# Master Sign Plan

## 15-90 MSP – BSD Scioto River Neighborhood District

### Big Sandy Superstore – Dublin Village Center 6825 Dublin Center Drive

Main Entrance Detail

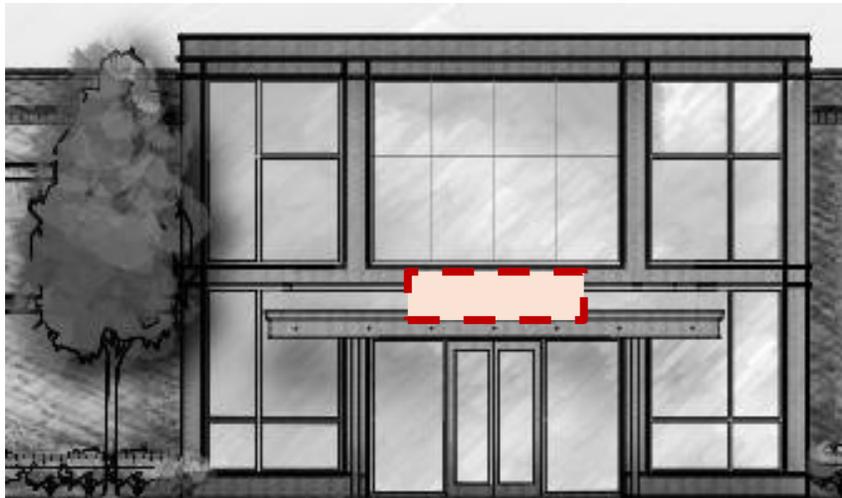
The red box in the diagram is an approximation of the maximum allowable sign area. The yellow boxes describe the approximate area of the proposed signs.

The proposed primary entry sign was sized to be proportional to the scale of the entry. The entry atrium is 3,760 sq. ft. The sign is 374 sq. ft. in size, which equates to 10% of the atrium entry area. Code allows 1/2 sq. ft. of sign for each lineal foot of building wall with a maximum size of 50 sq. ft. The "Big Sandy" text is proposed as red channel letters and is attached to the main entry curtain wall system. The "superstore" is proposed as a script font, with open face channel letters with LED tube outline, mounted to the entry canopy (the accompanying image illustrates this design approach). Both type face styles are part of the Big Sandy trademark. Due to its placement above the entry canopy, the proposed sign height is 20'-2", which is 5'-2" higher than the allowable 15' height.

Approval is recommended of the Master Sign Plan to permit one primary wall sign that exceeds the Code requirement for size and height, and two secondary wall signs that exceed the number of allowable wall signs for a single tenant entry façade and exceed the allowable distance from the front façade, with one condition:

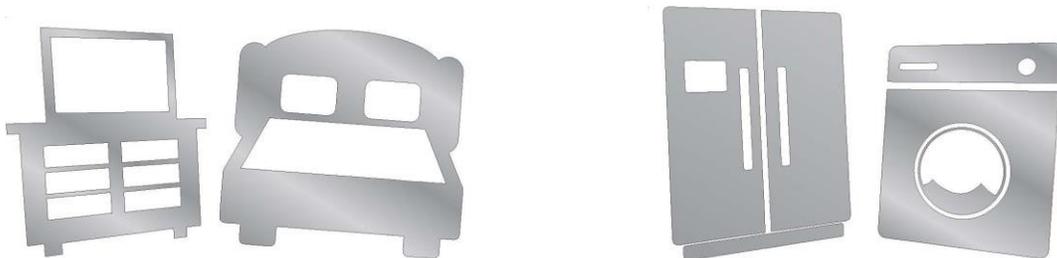
The sculptural panels mounted in the atrium are not part of the Master Sign Plan per Code, as they are mounted approximately 6-12 feet behind the glass curtain wall. The graphics proposed are cut metal panels, fabricated locally in the shape of the store merchandise. They are permanent installations that do not include text.

All icons will be halo lit brushed aluminum panels, mounted to the rear interior wall surface at a 2" depth.
